Re: GN Docket No. 96-228, Wireless Communications Service

WCS INTERFERENCE INTO SDARS ANALYSIS

ATTACHMENT B -TECHNICAL STATEMENT

FILTERING AND SIGNAL PROCESSING

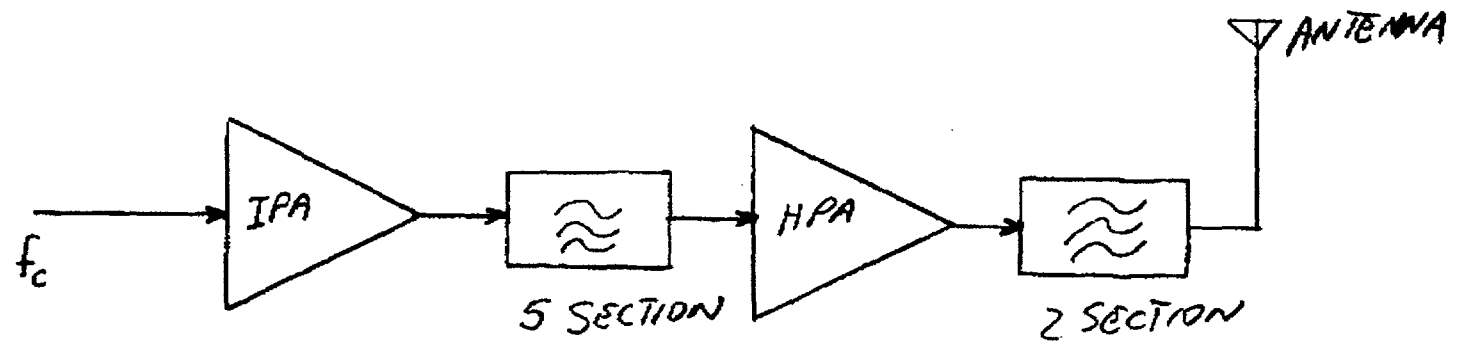
- **FILTERING DISTRIBUTED THROUGHOUT TRANSMITTER.**
- **MOST FILTERING TO BE DONE PRIOR TO FINAL POWER AMPLIFIER TO MINIMIZE IMPACT OF IN-BAND INSERTION LOSS.**
- **AMPLIFICATION AFTER FILTERING TO BE LINEAR AVOIDING SPECTRUM GROWTH.**
- **SIGNAL SHAPING PRIOR TO TRANSMITTER.**

POSSIBLE FREQUENCY PLAN

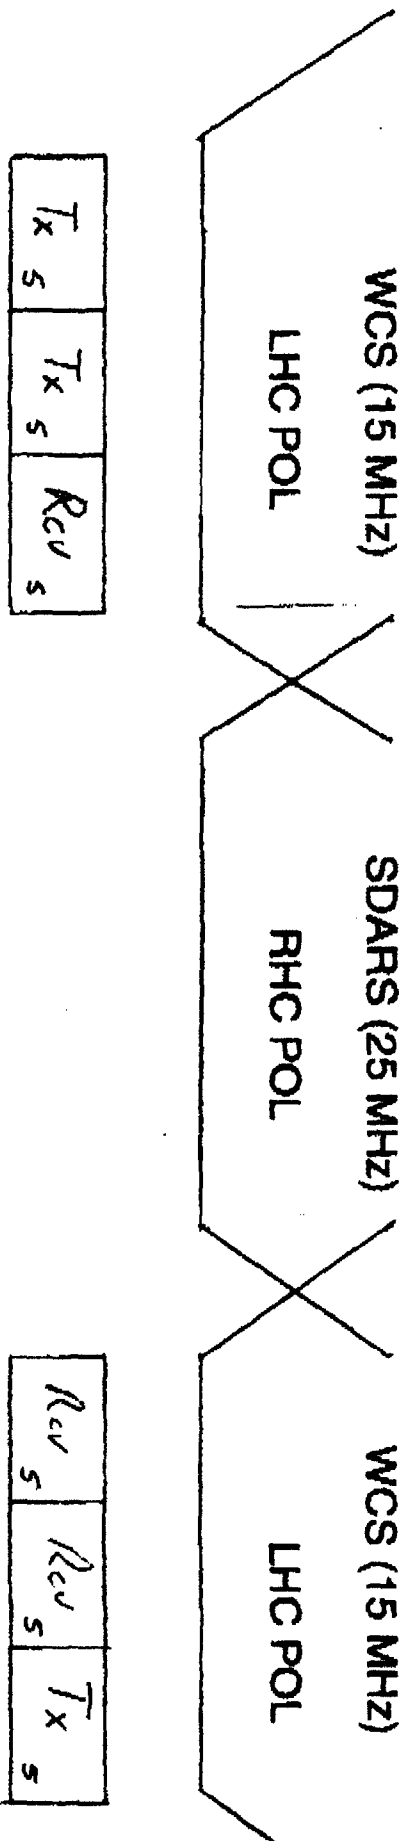
- FREQUENCY PLANNING + SIGNAL SHAPING + FILTERING + CIRCULAR POLARIZATION.
- CONFIGURATION

FOR EXAMPLE 7.5 MHZ AWAY FROM
EDGE OF SDARS $[(5 + 5/2)\text{MHZ}]$

IPA SPECTRUM ROLL-OFF	30 dB
5 SECTION FILTER	63 dB
2 SECTION OUTPUT FILTER	15 dB
CROSS-POLARIZATION ISOLATION	15 dB
TOTAL	123 dB
